## IN THE DRAWINGS

Please amend the drawings as follows:

The attached sheets of drawings, sheets 1 through 6, include amendments to FIGs. 2, 3, 4, 7, 8, and 9. These sheets replace the original sheets 1 through 6.

FIG. 2

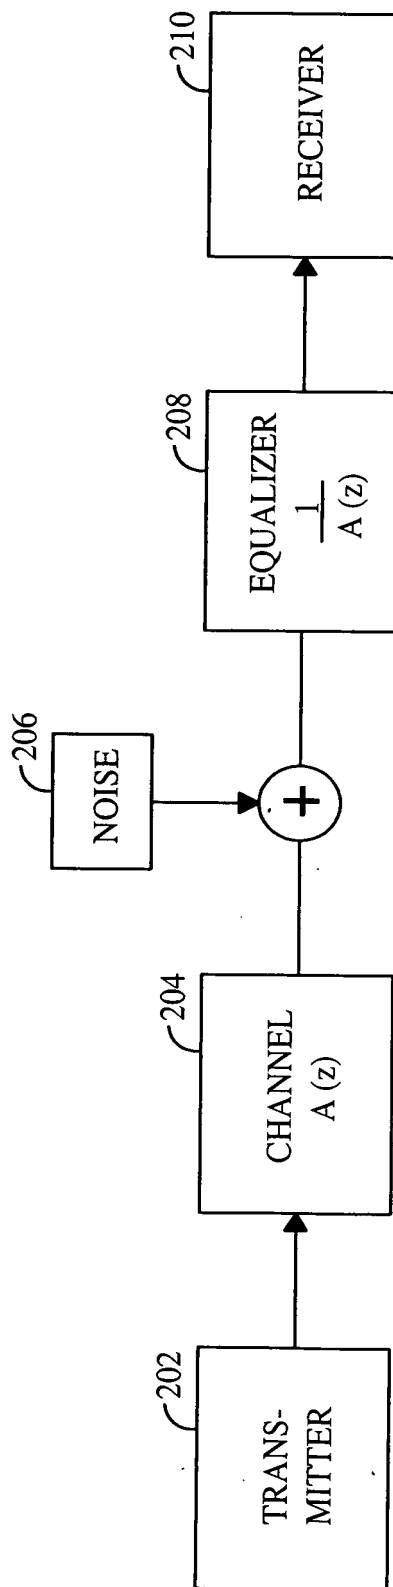
Specifically, Applicant amends FIGs. 2, 3, 4, and 9 to correct minor typographical errors. FIGs. 2, 3, and 9 have the argument of the function "A()" changed to the discrete complex variable "z" instead of the mistyped "2" in the original drawings. FIG. 9 also has the equalizer transfer functions corrected to be  $H1(z)$  and  $H2(z)$  consistent to the specification. FIG. 4 has the label added for communication system **400** consistent to paragraph [1028]. The name of element **412** in FIG. 4 was inadvertently omitted. This element has been labeled "controller." Paragraph [1035] in the specification as originally filed refers to "the controller **412**." Hence, this correction does not constitute new matter.

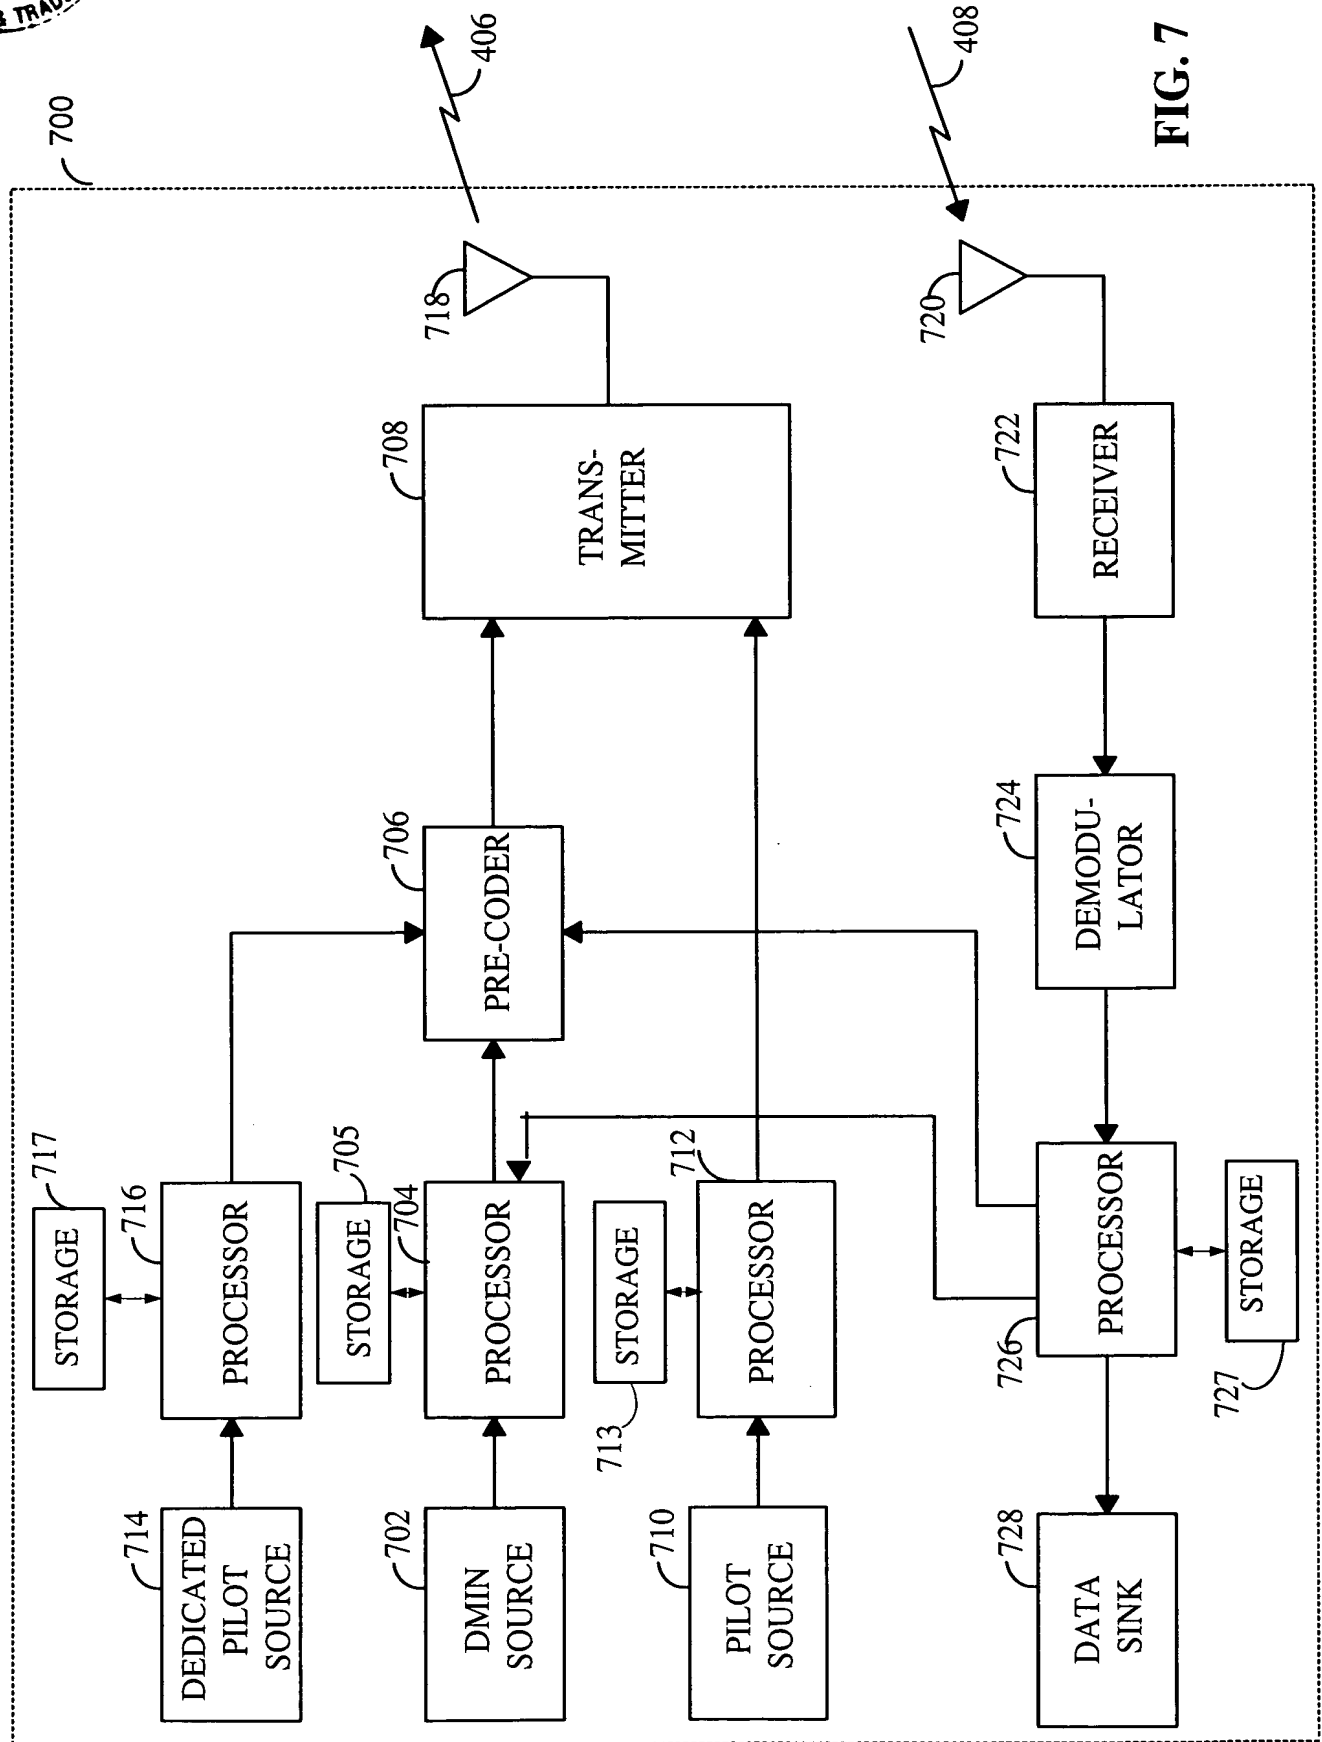
FIGs. 7 and 8 are amended to have storage attached to all processors to comply with examiner's objection that the drawings must show every feature of the invention specified in the claims. Applicant states that the addition is not new matter because digital processing and computation inherently involves some sort of storage, either separately or distributed among the processing elements, or both. Further paragraph [1059] in the original specification discusses various storages media that can be coupled to the processor.
